AMENDMENT #1

ITB/FJI/JPN/001/22 – Construction of EOC buildings in the Marshall Islands

This is in reference to the ITB/FJI/JPN/002/21 dated 04 April 2022 for construction of Emergency Operations Center buildings in the Republic of Marshall Islands.

A. MAJURO EOC Landscape Area and Rainwater Tank

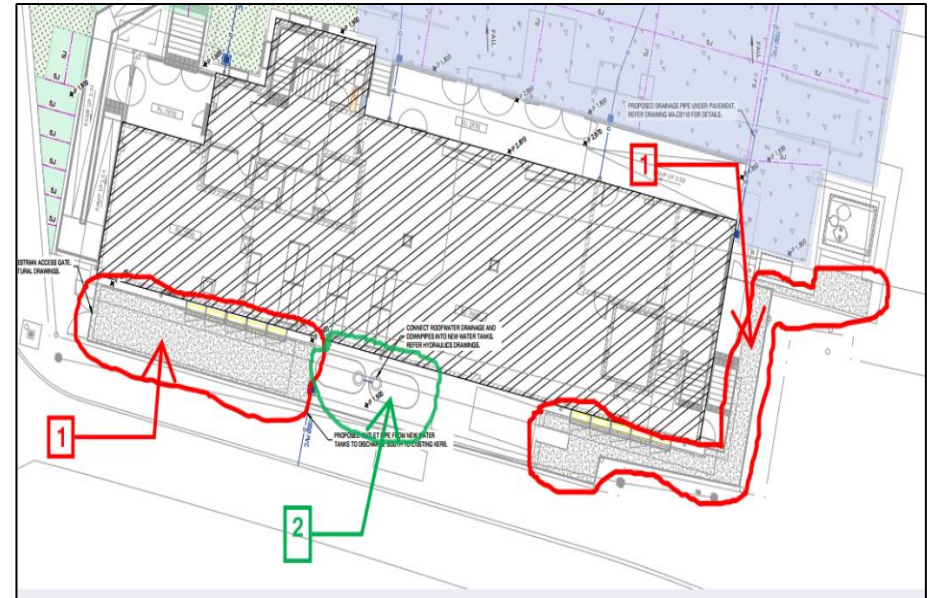
1. Landscape Area Enclosed in Red
 - 100 mm Gravel
2. Rainwater Tank and Pump Set Enclosed in Green
 - RW Tanks: 2 x 7,000L Steel Tank (Aquaplate Modline or equivalent)
 - Pump Set: Duty: 0.5L/s @ 500KPa with Poly Pump Cover or equivalent

B. MAJURO EOC AG Drain (All Throughout the Inner Perimeter of Building) Enclosed in Red

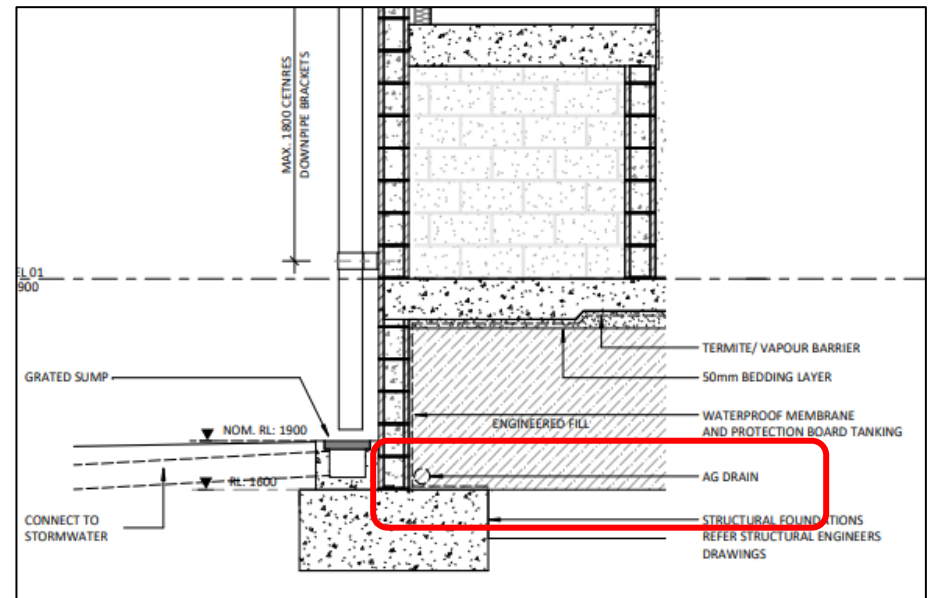
- Ag Drain not Required
- Aggregate / Granular Fill not Required

C. EBEYE EOC AG Drain (All Throughout the Inner Perimeter of Building) Enclosed in Red

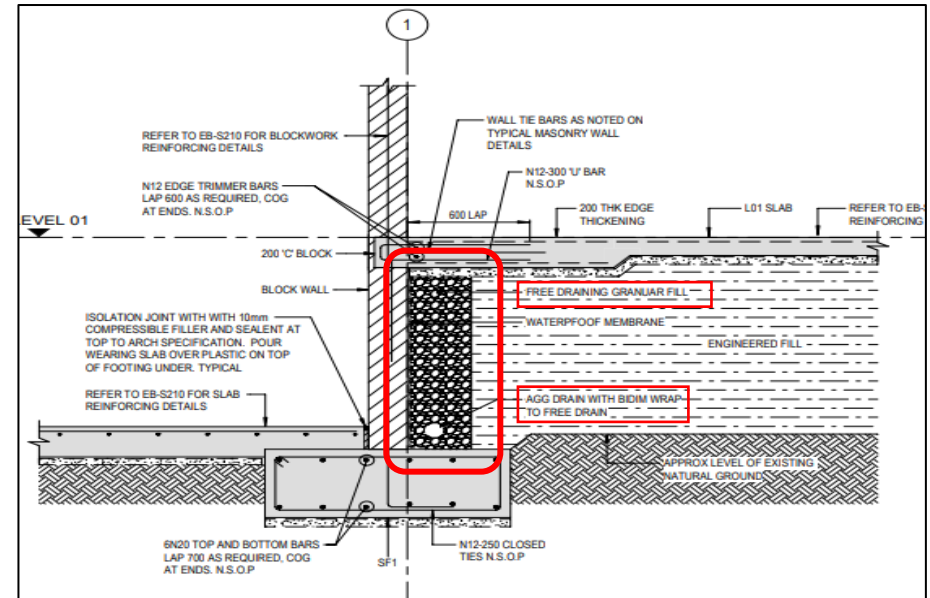
- Ag Drain in Bidim Wrap not Required
- Free Drain / Granular Fill not Required

D. EBEYE EOC Level 2 Slab Opening for Mechanical Services Provision

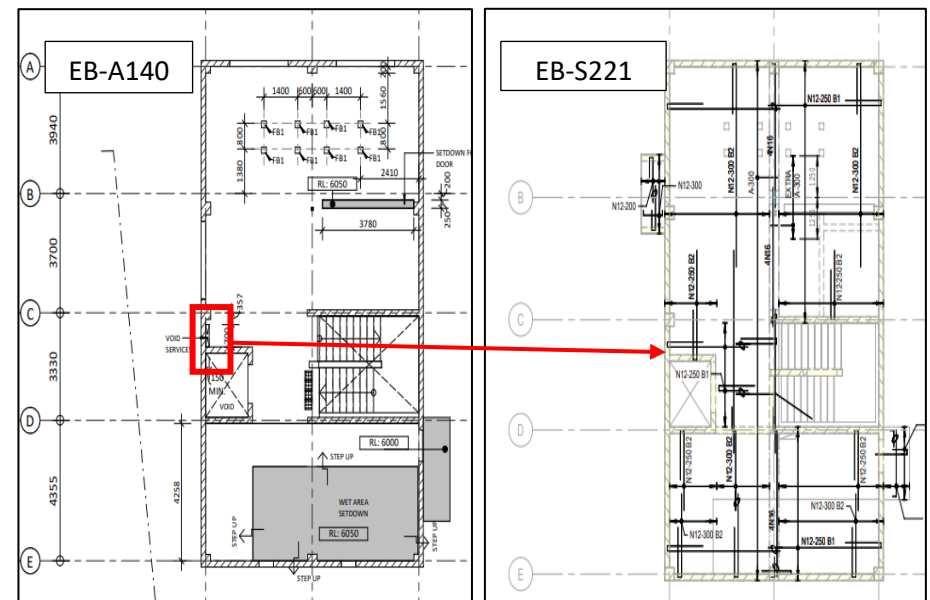
- **Architectural Plan EB-A140 Shows Void on Slab for Services but Structural Plan (e.g. EB-S221) did not Reflect the Opening. Adjust and Revise the Reinforcement to Incorporate this Opening.**

E. EBEYE EOC Missing Window Mullions in BOQ and Drawings

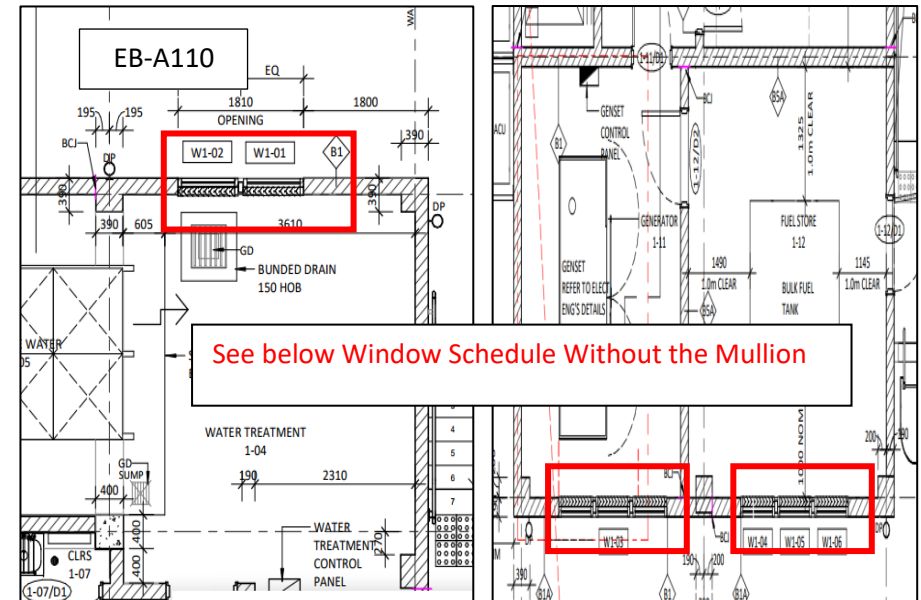
- Architectural, Structural Plan and BOQ did not show Detail/Information of Mullions in Level 1 Windows. **Include 125 x 75 x 6 RHS. Drawings to follow.**

Note: Please price additional 0.21t mullions under structural steel items 9.08 - Columns. The total quantity would be 0.28t.
